Bulletin No: SB2004-10

Machine/s: Model 230

SUBJECT: Drive Axle Seal

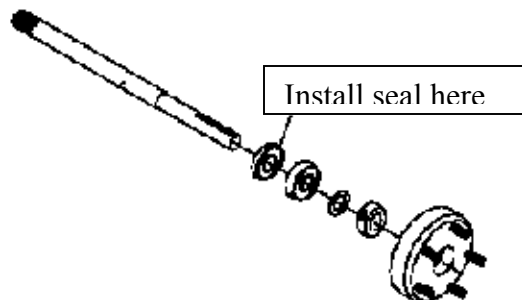
Oil leaking from inside axle seal on shaft part number 51-024.

Install a seal part number 4134039, behind axle bearing (see diagram).
